## **APPENDIX C**

### **FIELD CHANGE REQUESTS**

**FIELD CHANGE REQUEST (FCR) FORM**  
**FWEC/CHURCH ROAD TCE SITE, MOUNTAIN TOP, PENNSYLVANIA**

Project Name: FWEC/Church Road TCE Site Project Number: 106-8706.0031  
Client: Foster Wheeler Energy Corp. Request Number: **FCR-01**  
Field Change Request Additional Field Activities Based on Confirmatory Site  
Title: Reconnaissance  
To: (b) (4) Location: Morris Plains, NJ  
Date: August 23, 2011

TITLE:  
Proposed Surface Soil Sample Locations for Shot Blast Sands Area  
Based on Detailed Site Reconnaissance – Former FWEC Facility Property  
FWEC/Church Road TCE Site, Mountain Top, Pennsylvania

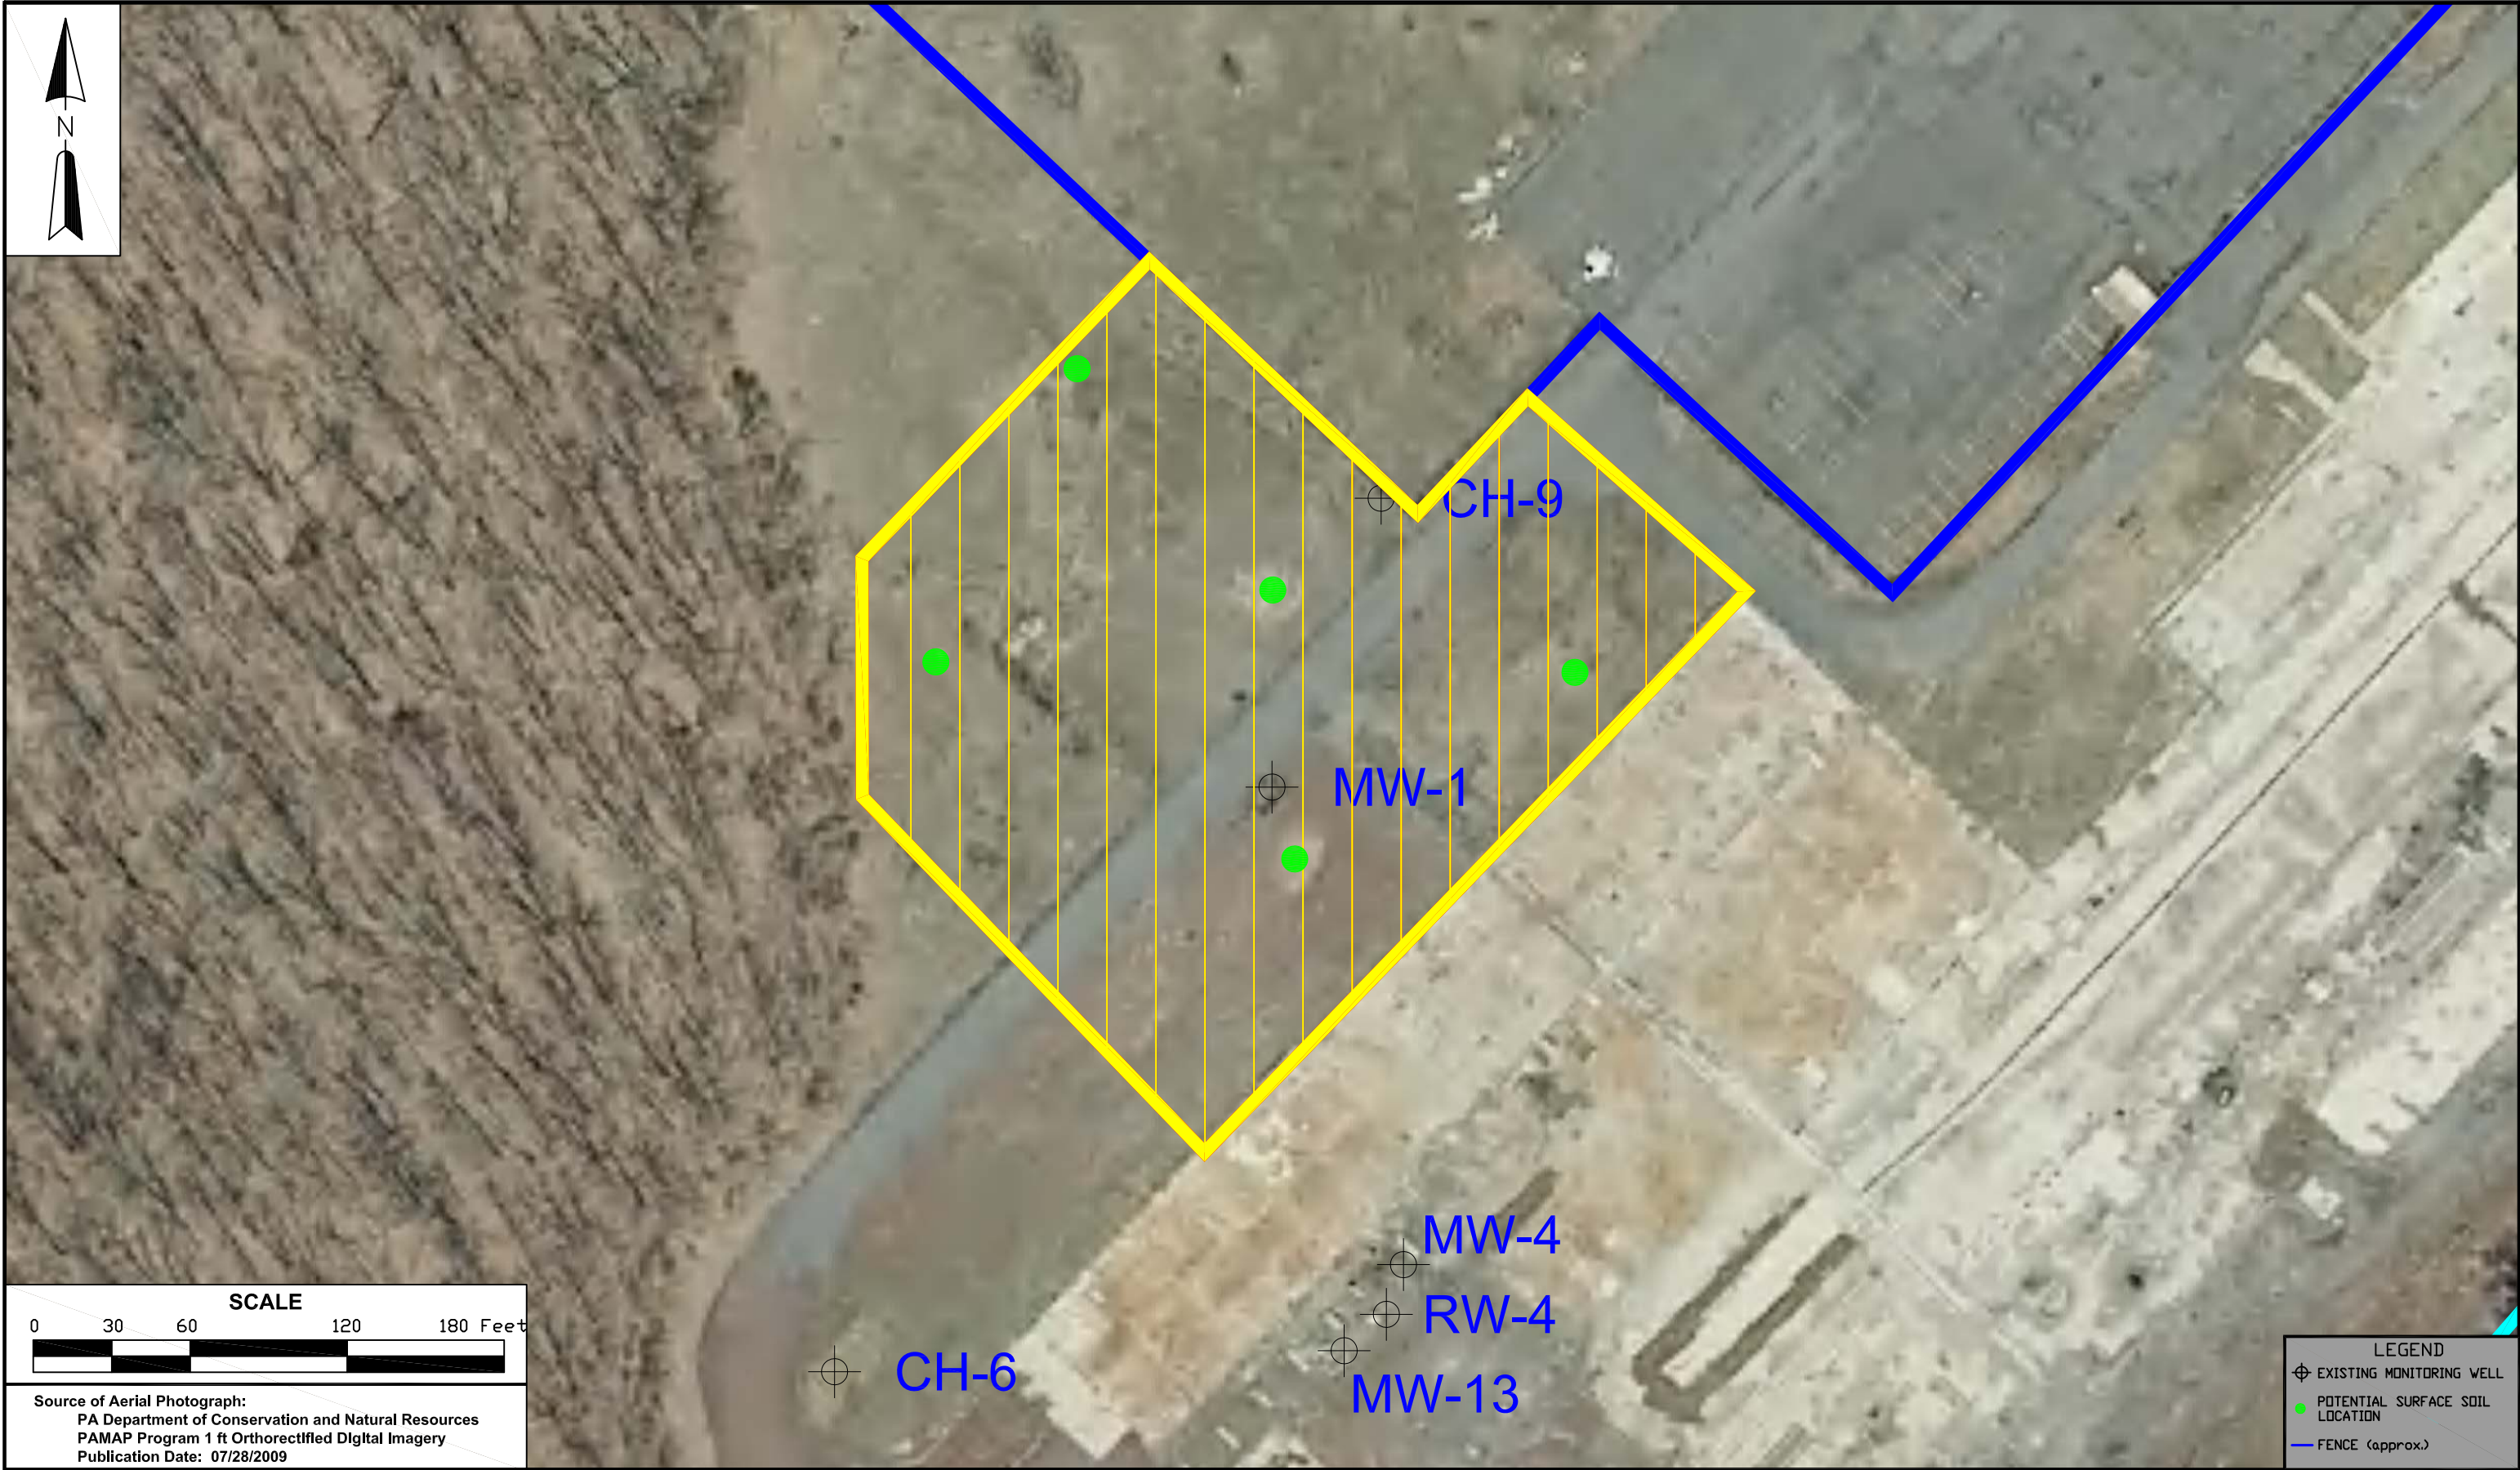
- Shot Blast Sands Storage Area – Five (5) sampling locations are recommended for this area, with four locations biased to areas with no vegetation and one placed down gradient of the area, estimated to be in a northward direction, to assess the potential surface runoff drainage pathway. Surface (0 to 6 inches) soil samples will be collected

for Target Compound List (TCL) Semi-Volatile Organic Compound (SVOC) and Target Analyte List (TAL) metals analyses.

I have reviewed this change request, and recommend conducting additional sampling activities as described above.

TITLE:  
Proposed Surface Soil Sample Locations for Expended Waste Area  
Based on Detailed Site Reconnaissance – Former FWEC Facility Property  
FWEC/Church Road TCE Site, Mountain Top, Pennsylvania

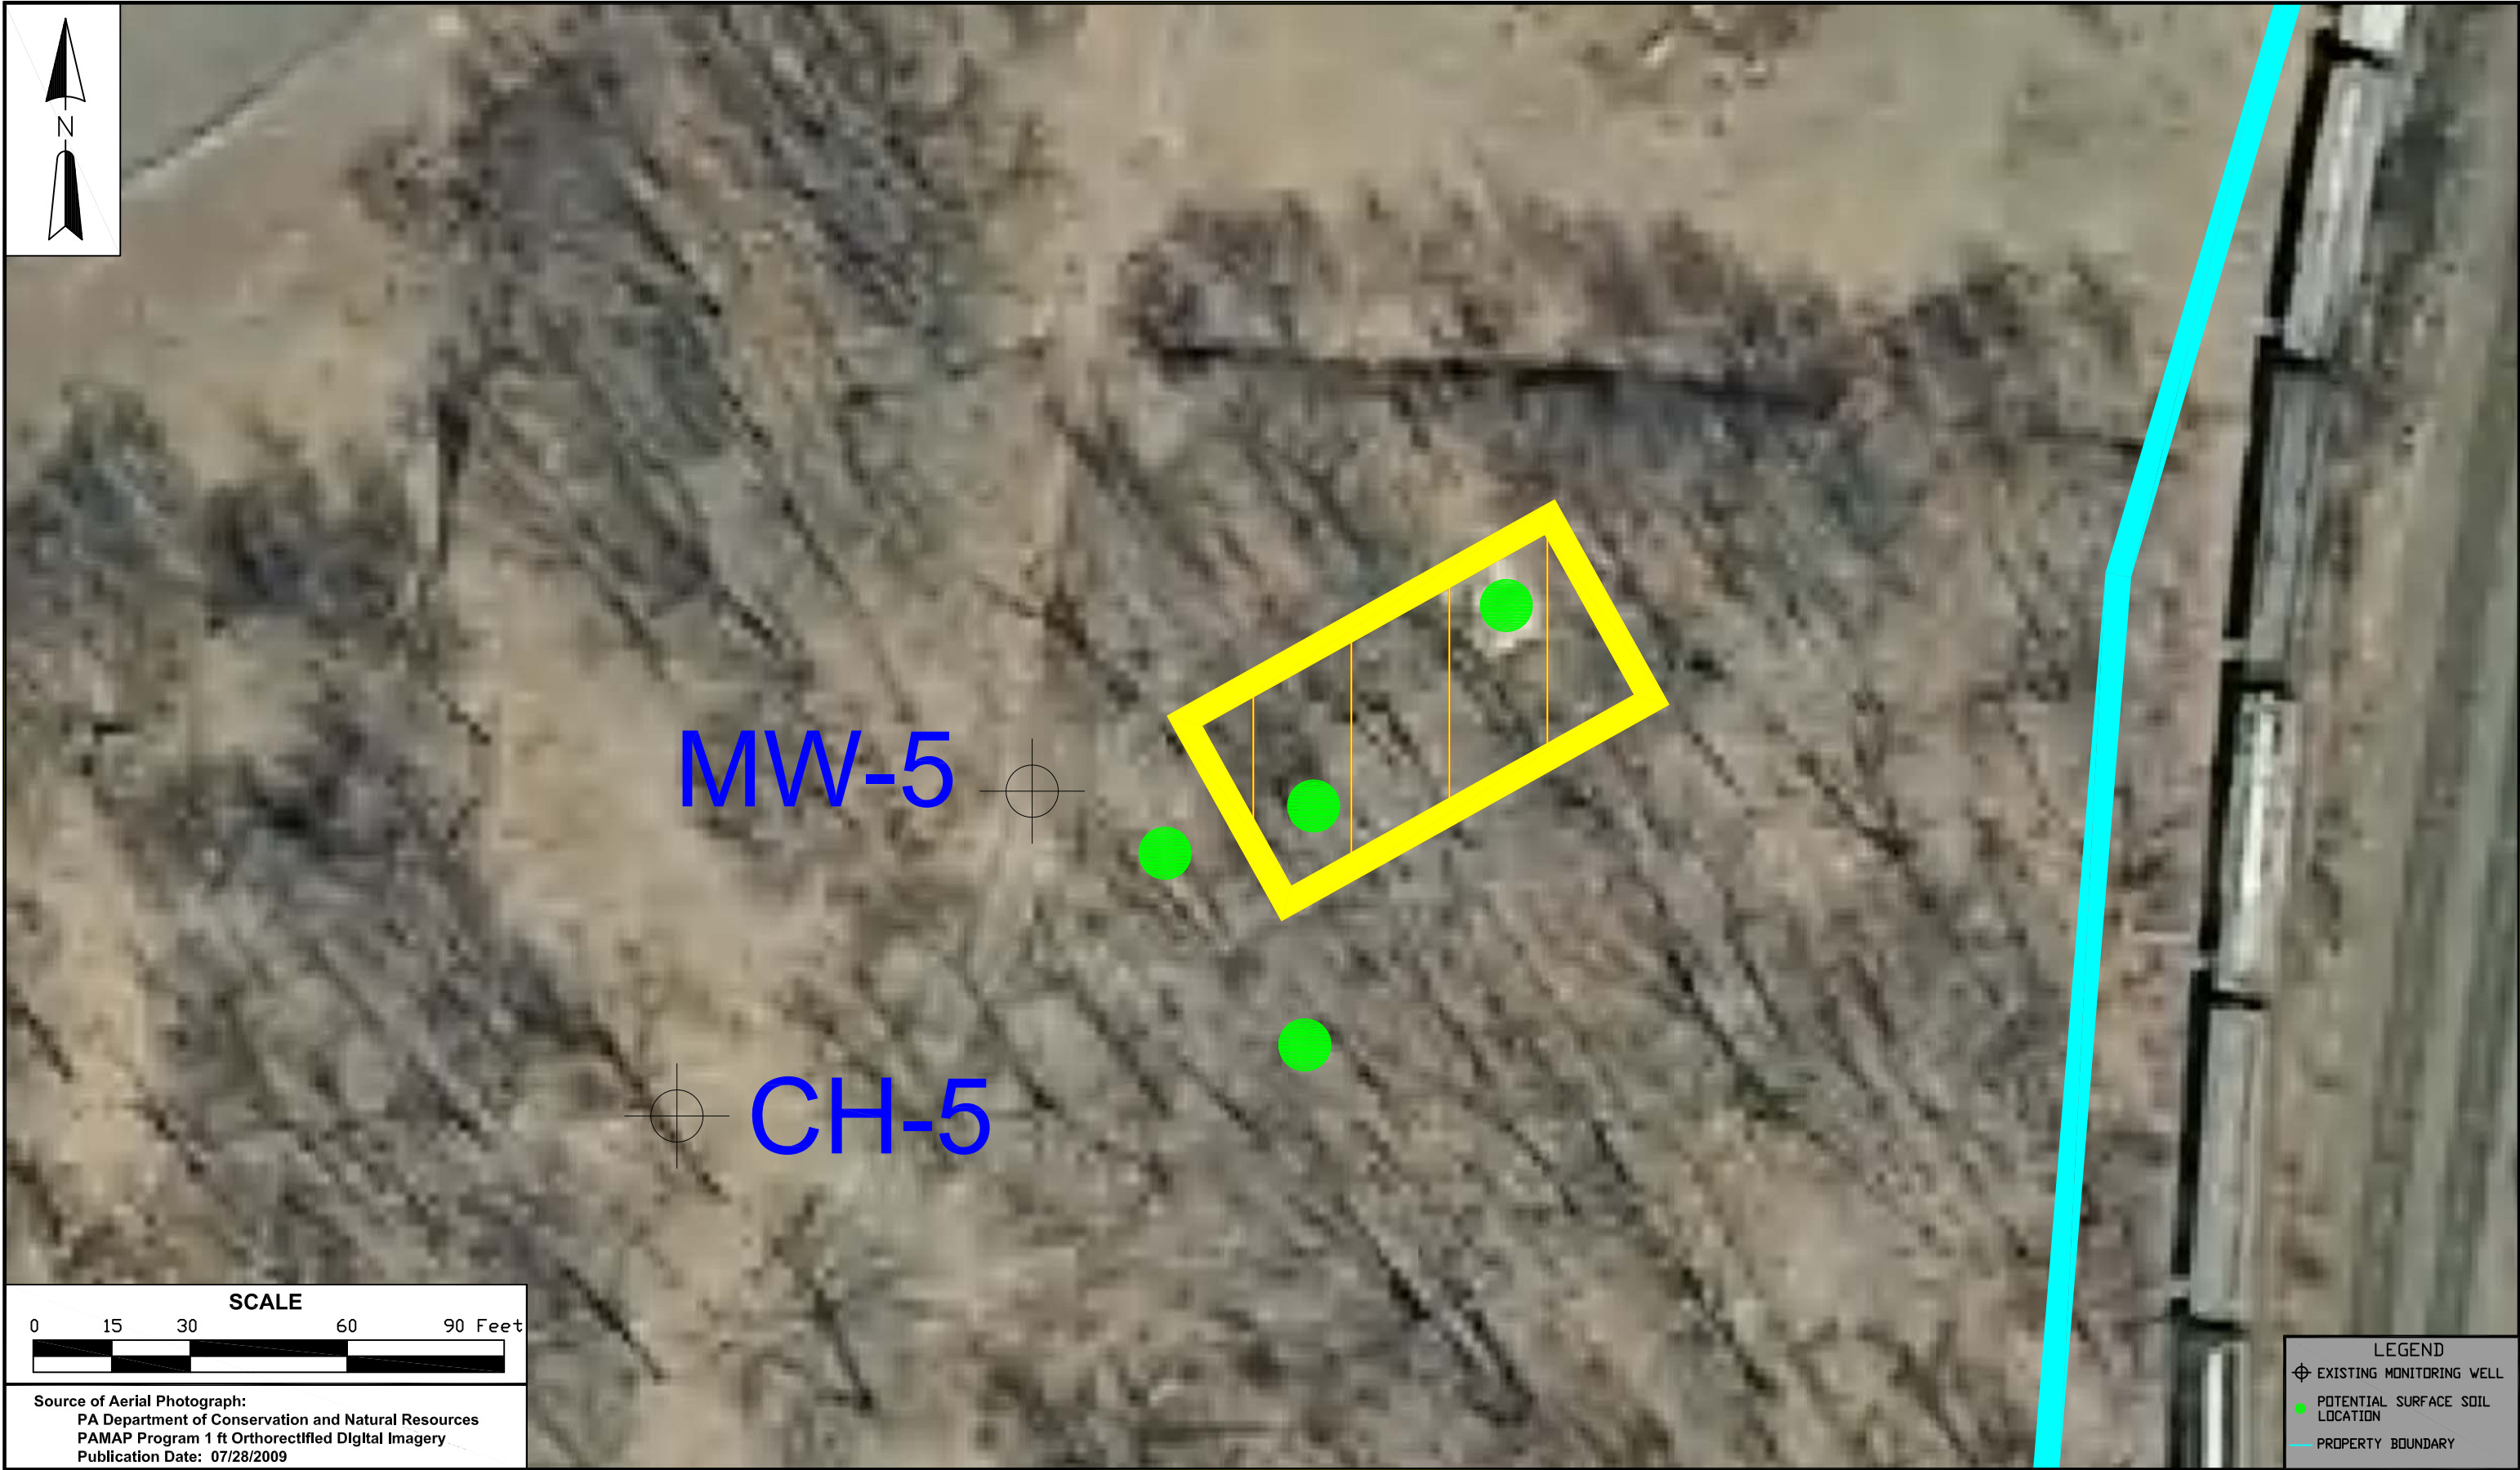
- Expended Waste Area – Four (4) sampling locations are recommended for this area, with two locations placed within the area and two placed down gradient of the area, estimated to be in a southwest direction, to assess the potential surface runoff drainage pathway. Surface (0 to 6 inches) soil samples will be collected for TCL SVOC and TAL metals analyses.
